**RE: REPLACEMENT OF STURROCK DRY DOCK (SDD) INNER CAISSON GATE AT THE PORT OF CAPE TOWN FOR A PERIOD OF 24 MONTHS**  
**TENDER NO: TNPA/2023/07/0011/34733/RFP**

We have been through the tender documents and have the following queries for you.

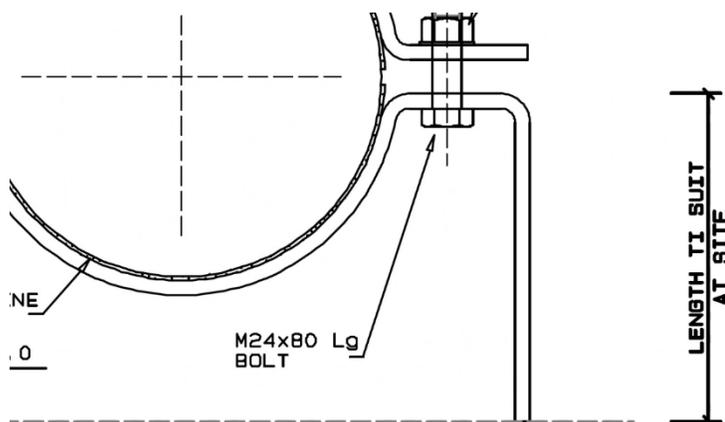
1. The spreader beam design including the designated lifting point on the structure is not clear in the tender documentation therefore unable to provide an accurate cost for this item. Kindly forward us the spreader beam design details and advise if excluded that contract rates can be used for this scope of work?

- **TNPA Response:** It is not clear what “spreader beam” is been referred to, however the scope details the crawl beam required for the caisson gate in section “10.1.3 Crawl Beam - For Installation and Maintenance of Valves” in the structural and mechanical specification. The dimensions are provisionally given as 180x90 I Beam (length to be determined from drawings with lifting capability by means of chain block arrangement, throughout the span of the beam.

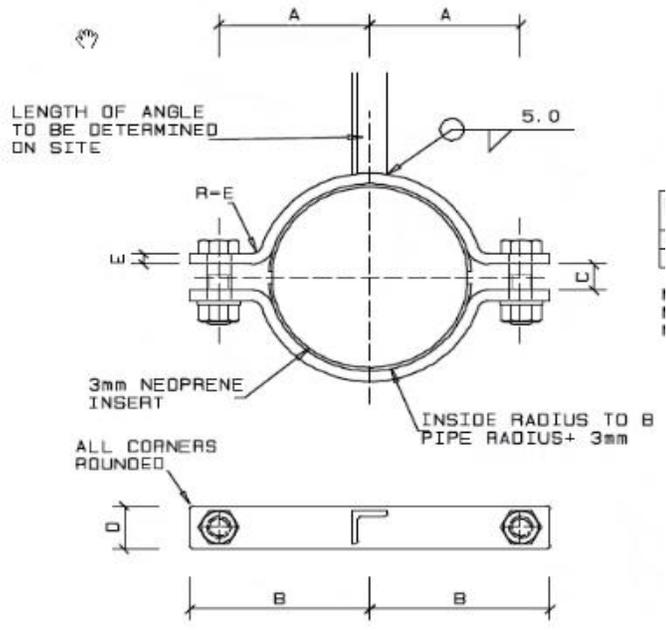
1. The BOQ details the material grade EH36 plate. Would it be acceptable to substitute the plate material as S355JR material grade?

- **TNPA Response:** No, it is not acceptable to substitute and EH36 plate needs to supplied accordingly, bidders to ensure strict adherence to provided scope of works.
